**RE: Smiles for Kids Dental Office – Site Expansion**  
**Conceptual Grading and Drainage Plan**  
**Stamp Date: 02/21/18**  
**Hydrology File: C12D056**

Based upon the information provided in your submittal received 02/22/2018, the Conceptual Grading and Drainage Plan **is not** approved for Site Plan for Building Permit. The following comments need to be addressed for approval of the above referenced project:

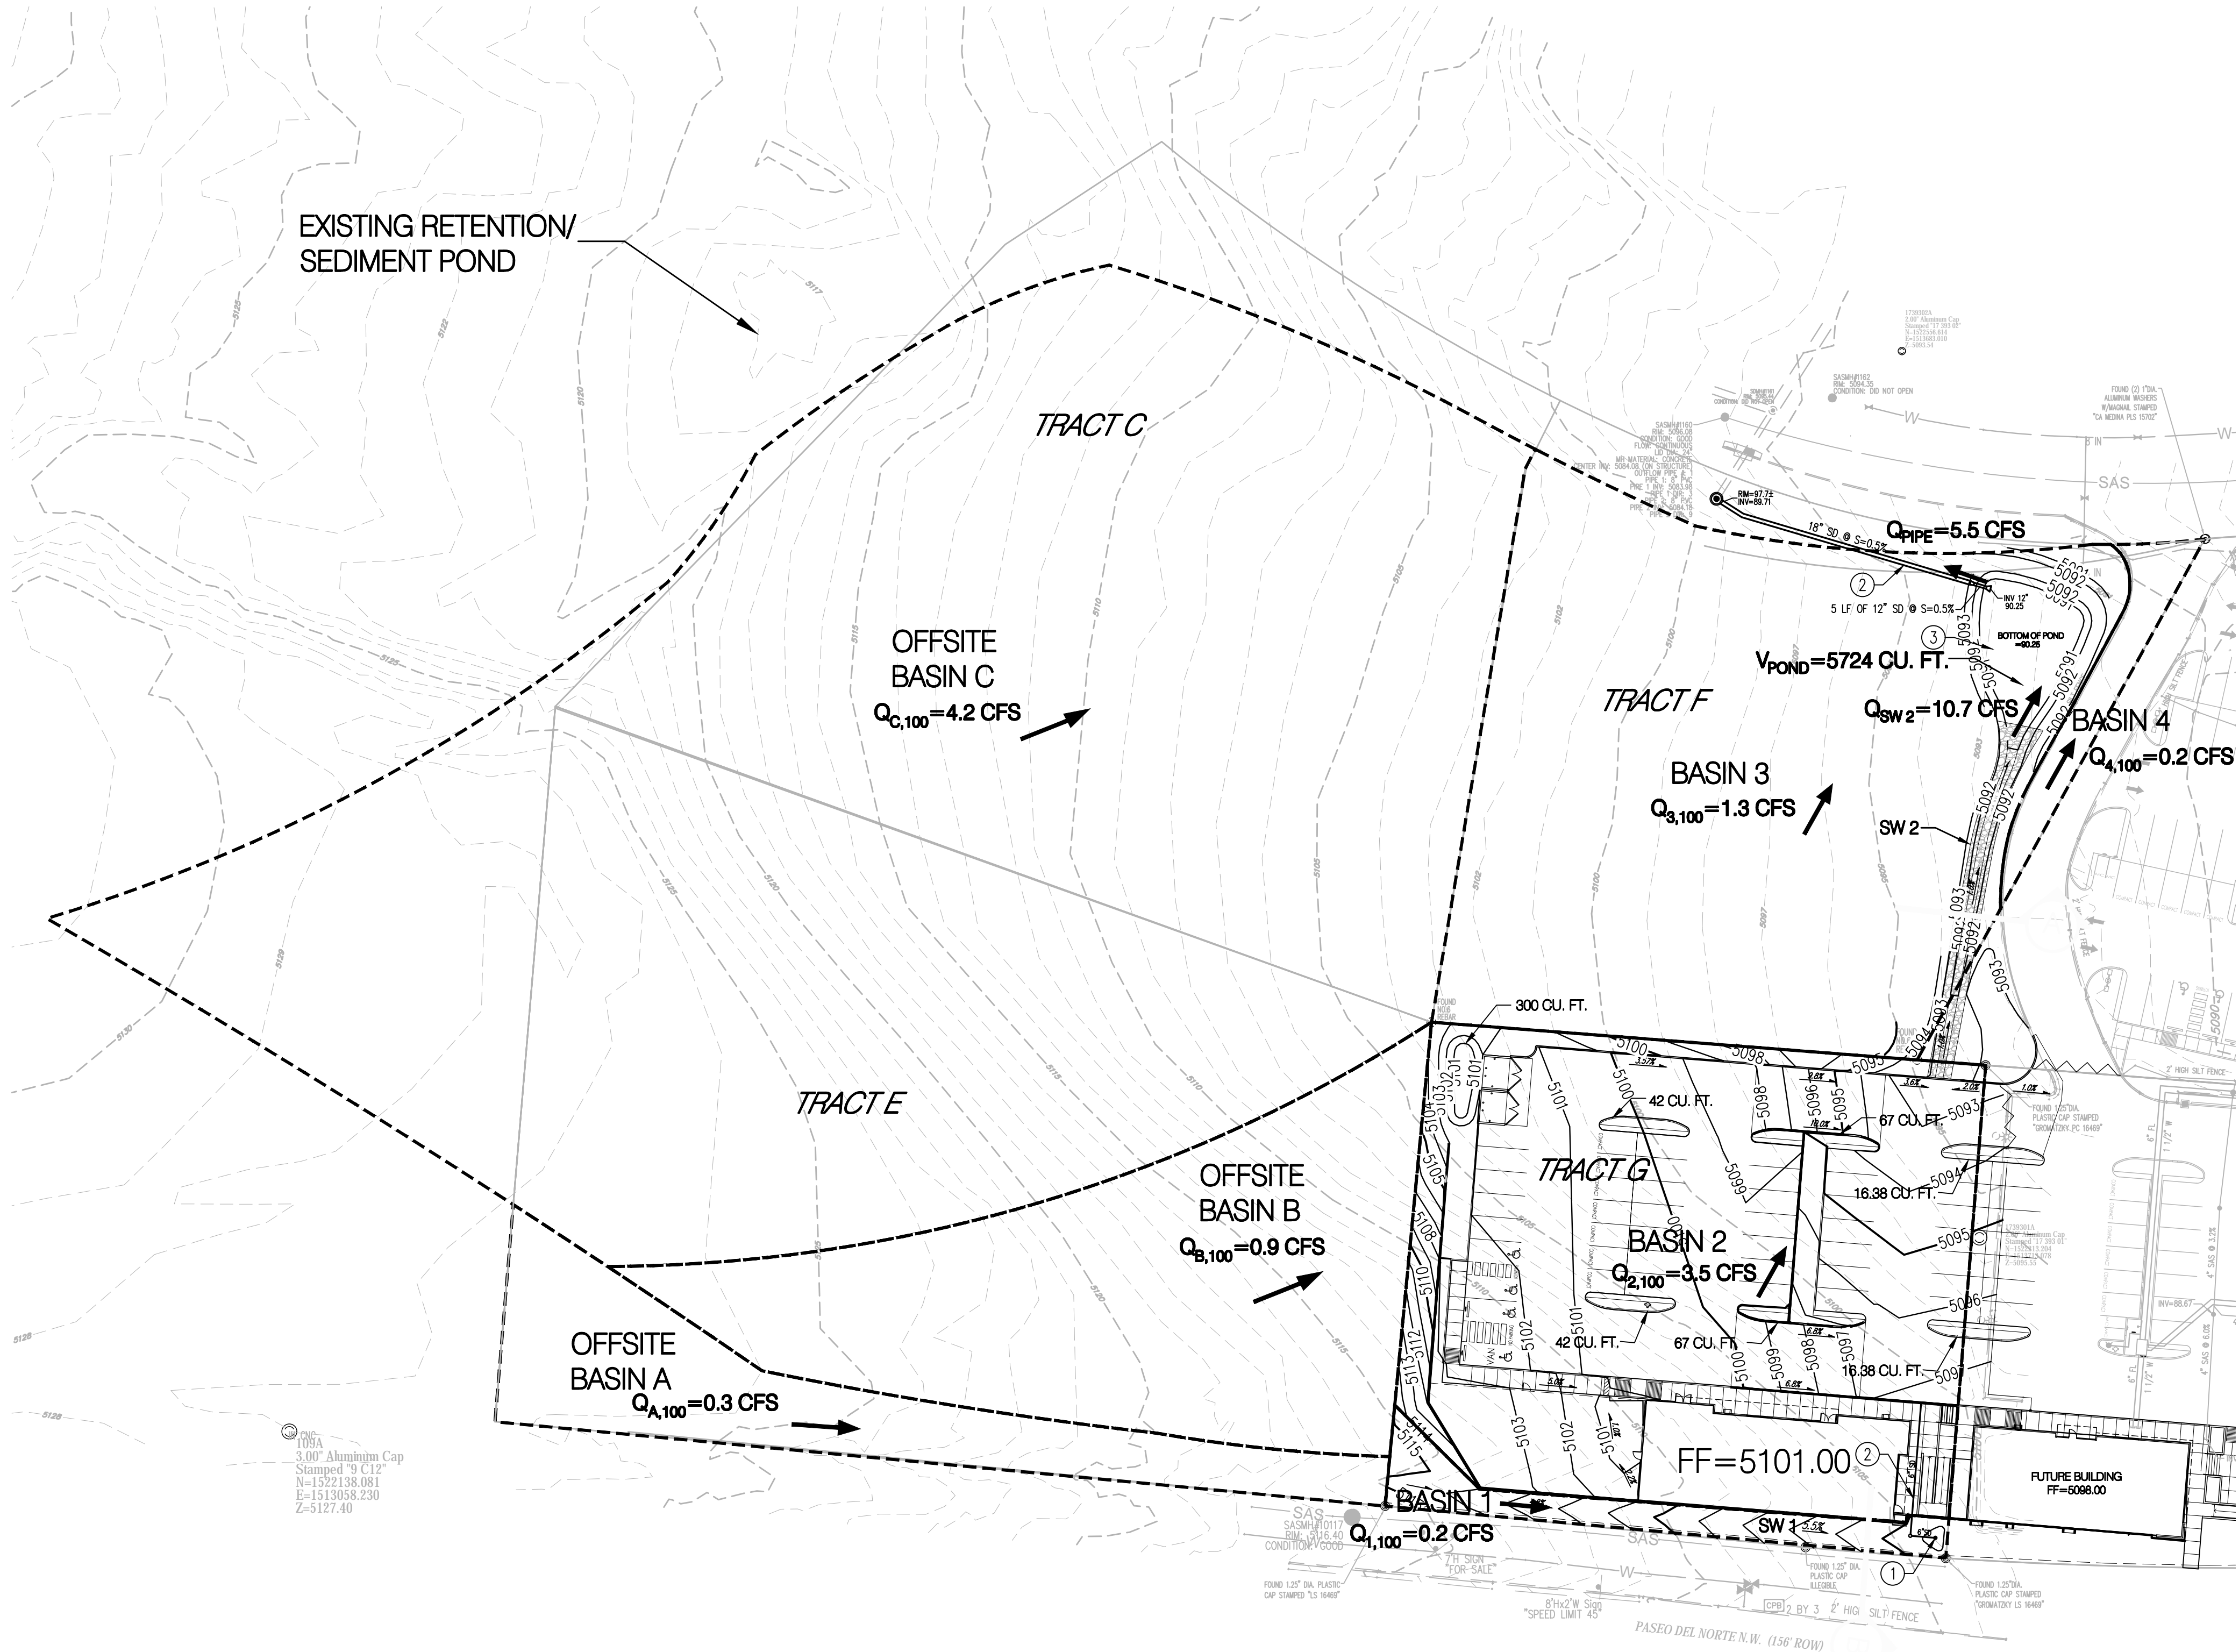
1. Please show and label the existing information within the ROW of Nunzio Ave (extend the ROW information past Tract C) on both Sheets C001 & C101. This can be taken from the latest aerial (Google Earth).

2. Please show a private drainage easement along the proposed Swale, detention pond, and the segment of the private storm pipe on Sheet C001, C100, & C101.

3. Please label Tract H and Lot 10-A-1 on Sheet C001.

4. Please correct the flow arrow on Drainage Areas for Basin 3 & Off-site Basin C on Sheet C001.
